#### 183rd session

## Proposal for Supplement 3 to the original series of amendments to UN Regulation No. 150 (Retro-reflective devices)

### Submitted by the Working Party on Lighting and Light-Signalling\*, \*\*

Figure A24-II  
**Simplified marking examples for grouped, combined or reciprocally incorporated devices**

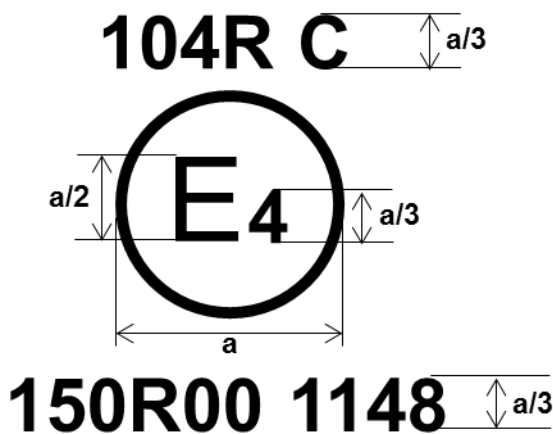
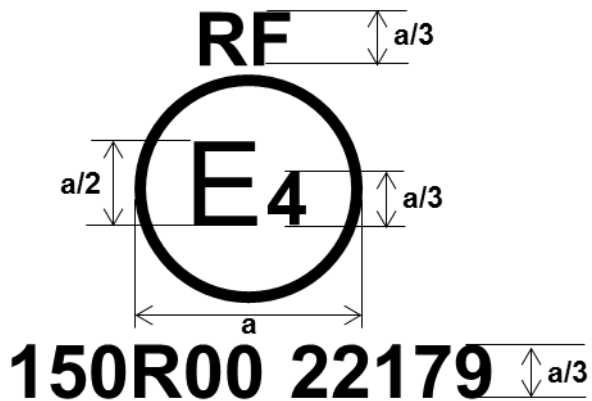
*Note:* The two examples of approval marks, models D and E, represent three possible variants of the marking of a lighting device when two or more lamps are part of the same unit of grouped, combined or reciprocally incorporated lamps.

Figure A24-IV  
Arrangement example of the approval mark for rear marking plates and SMV

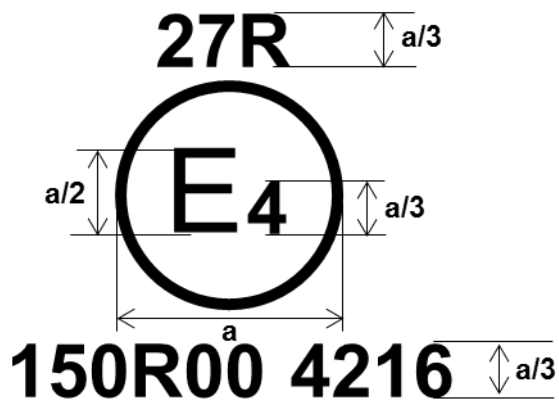
For a = see Table 1
